TSF WEEKLY INSPECTION FORM

Date: November 13, 2019	Time: 12:30
Weather: -18.6C; 33 km/h NW; overcast	Inspected by: Jennifer Pyluk
Present: Alex Plasse

Placement Area: Center Cell

Photo 1: Recently placed tailings in center cell; view facing southwest

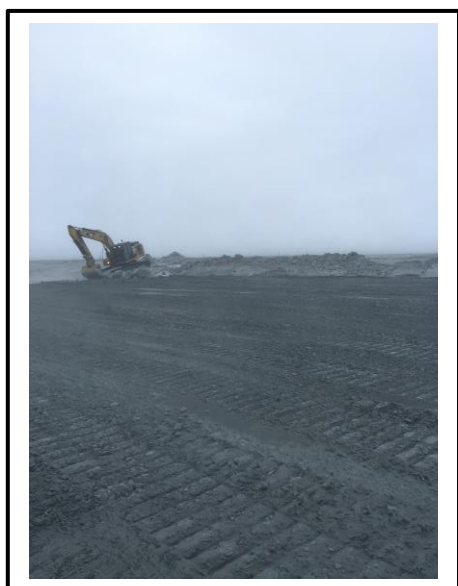
- Active tailings placement occurring over the past week in the center cell to approximate elevation 70.3 m.
- Considerable dust was observed to be generated from the surface of recently placed tailings material. This is expected to be due to the rough surface of the tailings material. At the time of inspection, tailings were being placed in a frozen or near-frozen condition and compaction was not occurring immediately after placement due to staffing issues. This resulted in a tracked surface only and dusty conditions.

- Placement should continue to focus on "filling in the holes" as issues regarding snow collection and removal will occur in these areas over the winter. These locations are the center cell, sub-cell 1 and between sub-cells 4/5. **Any excess snow/ice must be removed from trenches or the tailings/ground surface prior to placement.** No additional lifts are to be placed on sub-cells 2, 3, 4 or 5 at this time.

- Winter placement conditions must be followed in order to achieve proper compaction and reduce settlement in the summer months:
 - Tailings should be removed from the Church immediately** to avoid freezing of this material prior to placement. Stockpiling in the Church should only occur in extreme conditions.

- Compaction of tailings should also occur immediately following placement.** If compacted while unfrozen, the same number of passes (3 slow passes on high vibrate) applies. If frozen tailings material has to be placed, Engineering must be notified so that the least harmful placement location and compaction specifications can be chosen.

Photo 2: Recently placed tailings in center cell and dust; view facing north

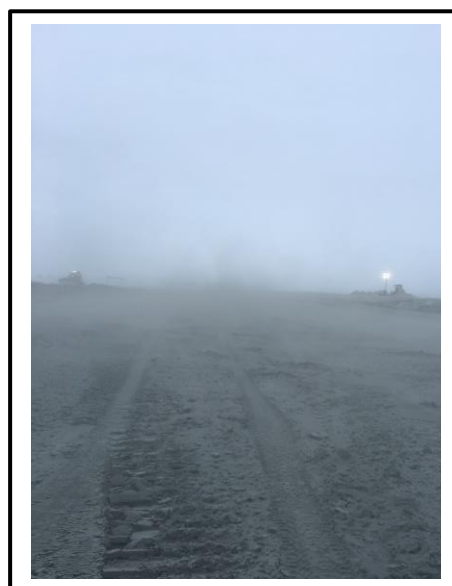
- It was observed that compaction specifications were not being obtained, particularly in the top 4-6", due to the placement of tailings material in the frozen (and dried) condition. It is noted that placement of already frozen material in the center cell is preferable from a stability standpoint however.

- There should be no vehicle traffic on the finished tailings surface.** Flash freezing of the surface will occur and erosion/dust generation will be at its peak. Traffic over snow will grind/compress the snow into the tailings surface and will make snow removal in these areas more difficult.
